Islam Knit Designs Ltd. (Unit-2)

301 NOYAPARA, KASHIMPUR, GAZIPUR
(23.989034N, 90.318997E)
23rd May 2017

Observations

Corrosion observed at steel sections

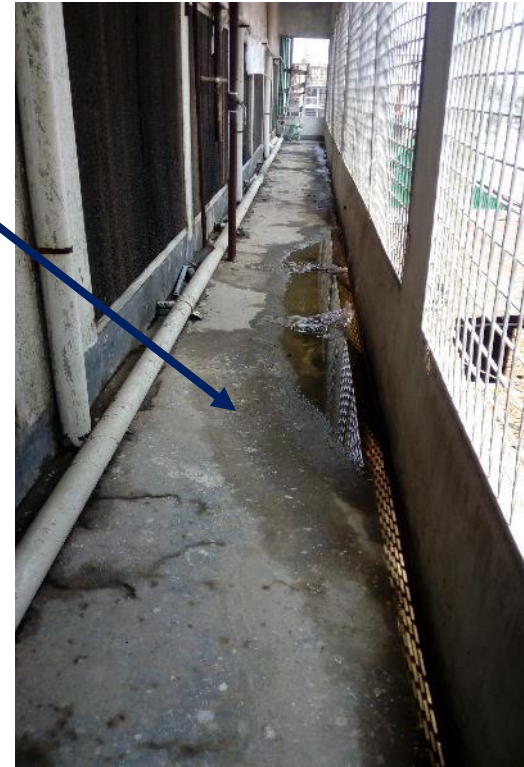
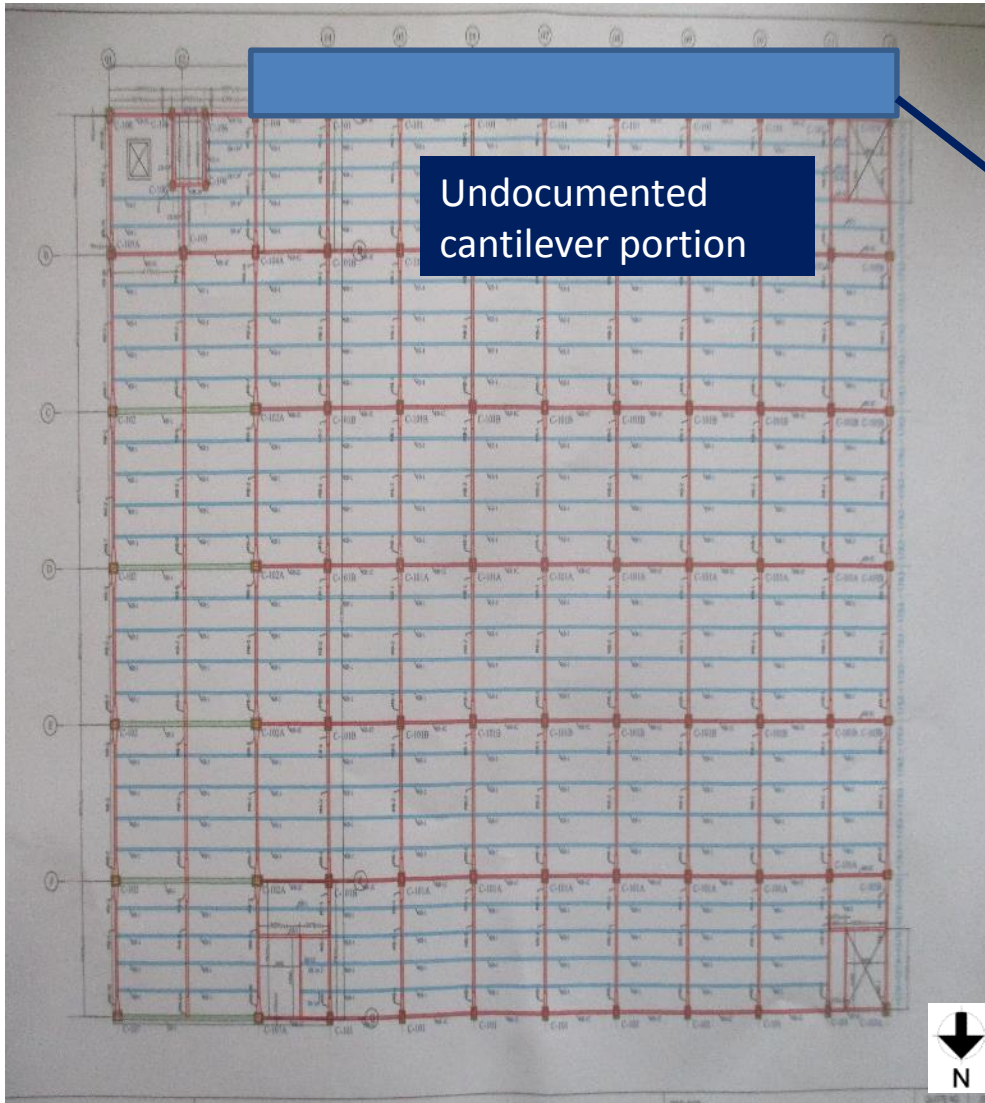
Corrosion at joint

Corrosion observed at ground floor

Corrosion at steel column

Corrosion at Sub Beam

Corrosion at joint

During inspection, Corrosion observed at structural steel section at several floors of the building.

Undocumented cantilever portion observed

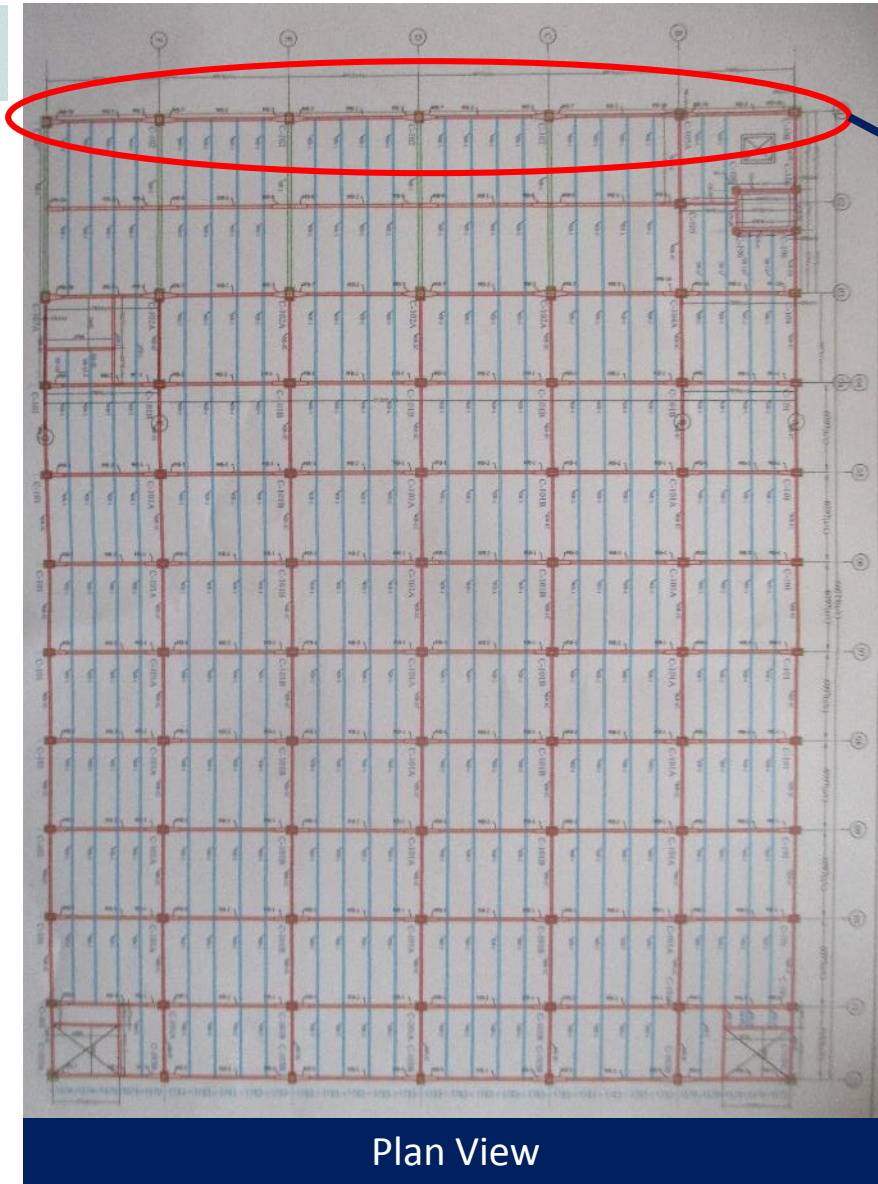
During inspection, a undocumented cantilever portion was observed. Building Engineer is required to update as built drawing including this.

Plan View

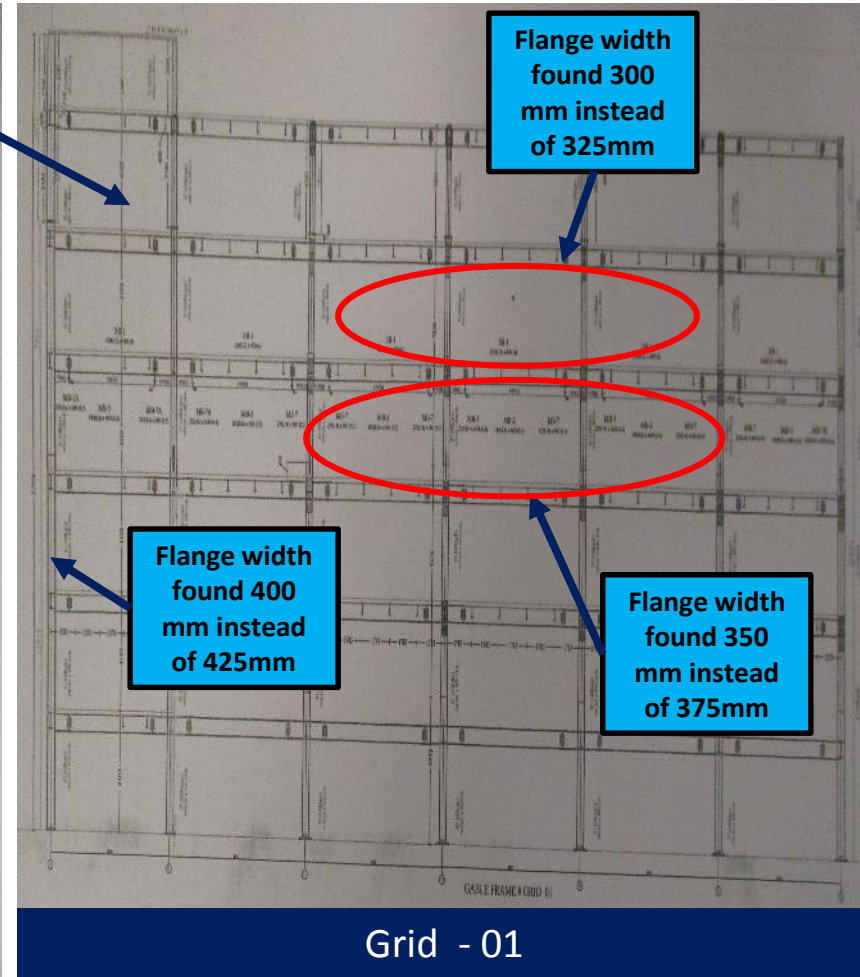
Discrepancy observed in construction drawings and site condition

During inspection, the flange width found less than provided drawing. Building Engineer required to prepare As Built drawing.
